Subject: **Application for Modification to Section 404 Nationwide Permit, Section 401 Water Quality Certification and Neuse Riparian Buffer Certification:**  
Widening of Interstate 85 from west of Broad Street to west of Camden Avenue, Durham County, Division 5; Federal Aid Project No. I-85-4(49)174:  
TIP No. I-0306DB: \$475.00 Debit WBS Element 34143.1.7

Reference: USACE Action ID 200020902  
DWQ Project No. 001040

The purpose of this submittal is to request a modification to the Section 404 and Section 401 Water Quality Certification and Neuse Buffer Certificate. This modification is for changes to stream impacts. However, the revised permit drawings also depict other changes to the hydraulic design such as revisions to riparian buffer treatment devices, changes to structure layout, design and size, and rock planting in the riparian buffer.

N. C. DEPT. OF TRANSPORTATION  
 DIVISION OF HIGHWAYS  
 DURHAM COUNTY  
 PROJECT: 8.1414801 (I-0306DB)  
 I-85 FROM WEST OF BROAD  
 STREET TO WEST OF CAMDEN  
 AVENUE IN DURHAM  
 rev. 3/04  
 SHEET 11 OF 27 rev. 1/04

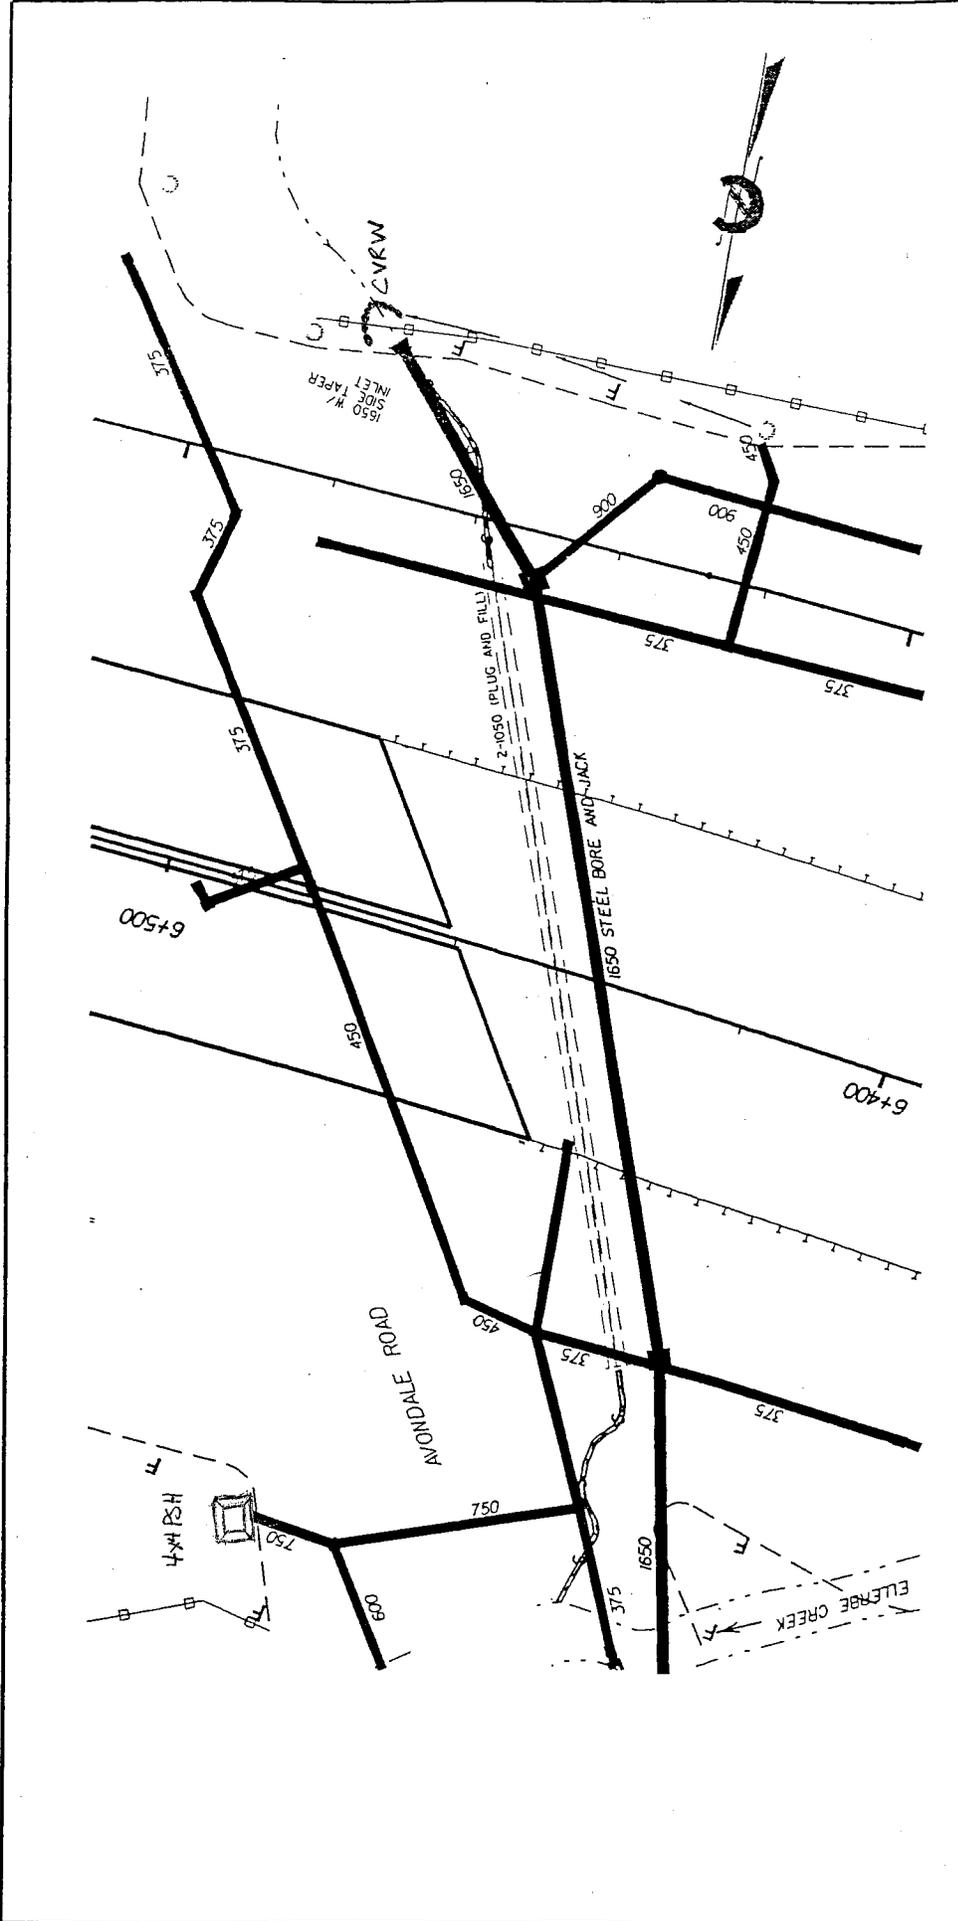
-Rock plating (approximately 110 linear m) has been installed in Zone 1 of the riparian buffer from 1+130 to 1+240 Lt –ROXB-. This was a requirement from NCDOT soils and foundation unit to stabilize the soils in this location.

-Rip rap toe protection (approximately 20 linear m) has been installed in Zone 1 and 2 of the riparian buffer along toe of the fill slope from 1+240 to 1+260 Lt –ROXB-.

-Additional rip rap has been installed to provide streambank stabilization along relocated Ellerbe Creek at Station 1+145 Lt –ROXB- at the outlet of a 900 mm structure. This has impacted 4 m of relocated stream.

-Revised pipe diameters have been depicted on structures located from 1+250 to 1+300 Lt –ROXB-.

-A 375 mm structure has been added that will drain to a 2 x 2 pre-formed scour hole at 0+340 Rt –Y6-. This is necessary to reconnect the outlet of an existing off-site catch basin that was inadvertently plugged during construction of the drainage system along Roxboro Road.

-A 2 x 2 pre-formed scour hole located at 1+290 Lt –ROXB- has been resized to a 3 x 3 pre-formed scour hole. A 900 mm csp structure outlets into this pre-formed scour hole.

**\*\*A total of 4 m of relocated Ellerbe Creek has been stabilized with rip rap at Site 13 on this permit drawing which will require mitigation.**
